MG Niche Flair Limited

340, Dighiborab, Jatramura, Rupgonj, Narayangonj
(23.720084,90.517635)

02 May, 2016

Mismatch of column & beam with provided drawing

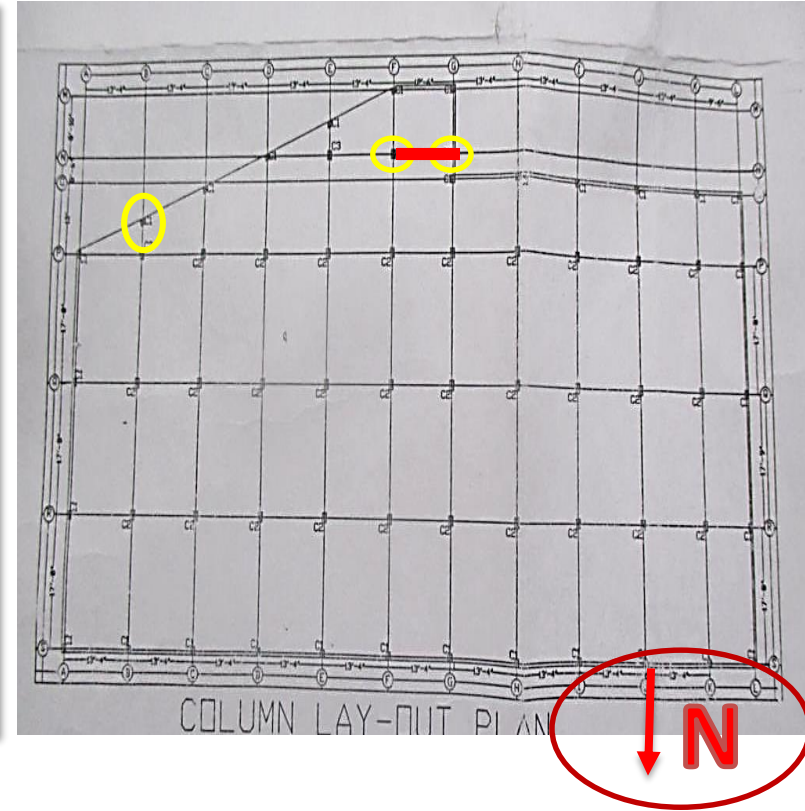
Columns(marked in yellow) and beam missing(marked in red) as per provided drawing

Mismatch of column & beam with drawing

| Item No. | Observation | Recommended Action Plan | Recommended Timeline |
|----------|--|---|----------------------|
| 2 | Mismatch of column & beam with provided drawing | The Building Engineer shall provide calculations showing the structural adequacy of members for missing beam and column | 6-weeks |
| 3 | Mismatch of column & beam with provided drawing | Factory Engineer to survey the building and prepare as-built drawing | 6-months |
